APPLICATION NO. A/H9/86 FOR PERMISSION
UNDER SECTION 16 OF THE TOWN PLANNING ORDINANCE

FURTHER INFORMATION SUBMISSION

Section 16 Application for Proposed Minor Relaxation of Building Height Restriction for Proposed Hotel Development with Shop and Services at "Residential(A)" Zone and Area Shown as 'Road' at Nos. 9-19 (odds) Kam Wa Street, Shau Kei Wan

Response to Comments Table

T:\JOB\J7400-J7449\J7439\2026 05\Fig 2.1 RevB.dwg

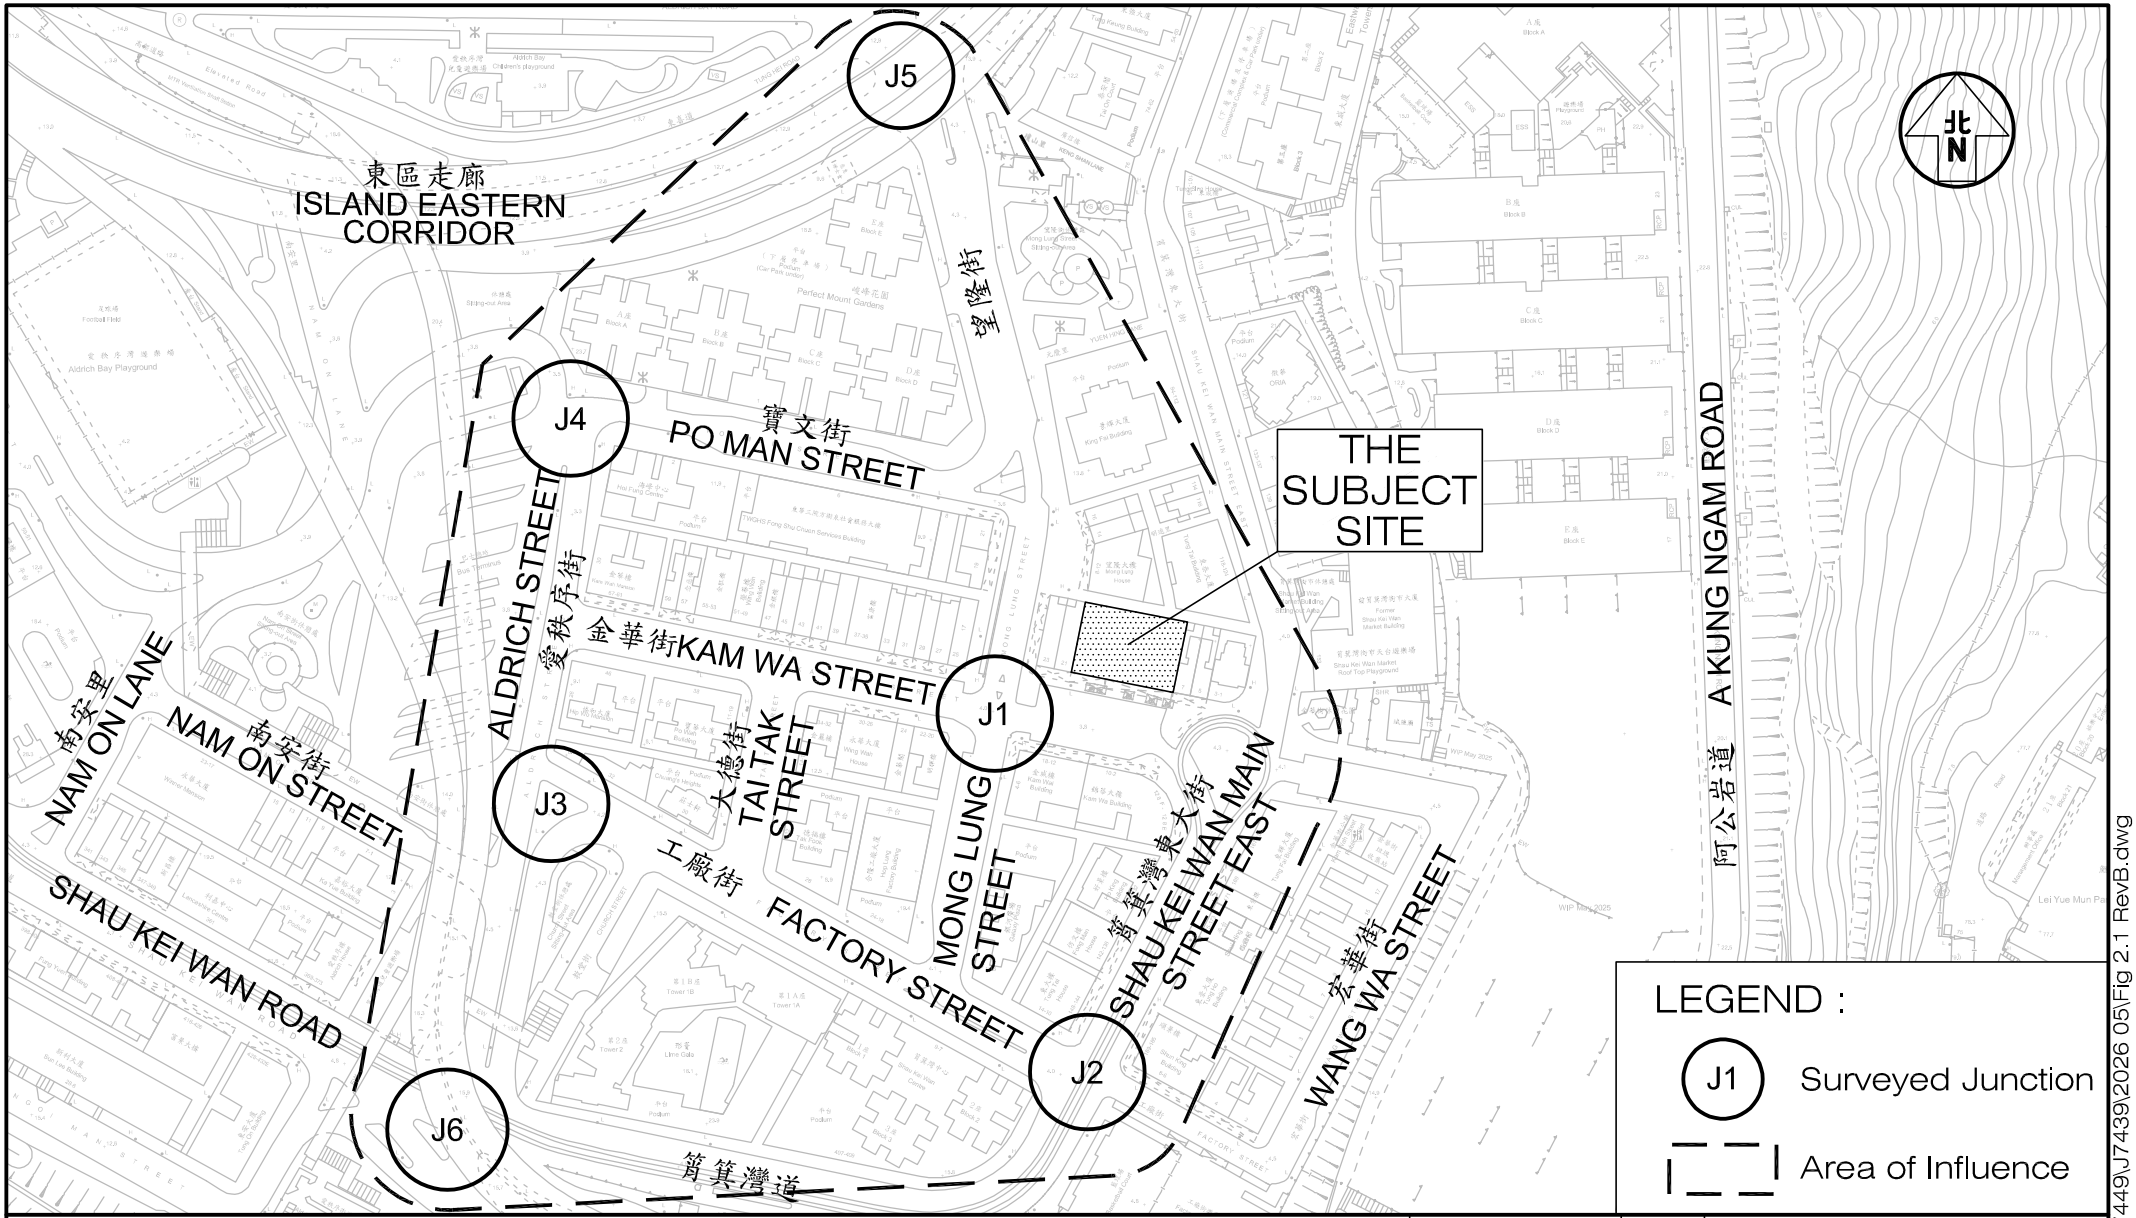
f	6) Para. 2.5, Para 2.6 and Figure 2.1 – Area of Influence should be proposed for agreement in TIA. It shall generally cover the area from the subject site to the nearby major interchanges with trunk roads. For the proposed development, it shall be including, but not limited to, the junctions of Shau Kei Wan Road/ Chai Wan Road, Aldrich Street/ Po Man Street and Mong Lung Street/Tung Hei Road.	Noted. Please refer to updated Figure 2.1, Tables 2.1 and 4.9 in the revised TIA.	
g	7) Table 2.1 – Please review and indicate the exact figures for the RC of Junction J3 in the table.	Noted. Please refer to updated Table 2.1 in the revised TIA.
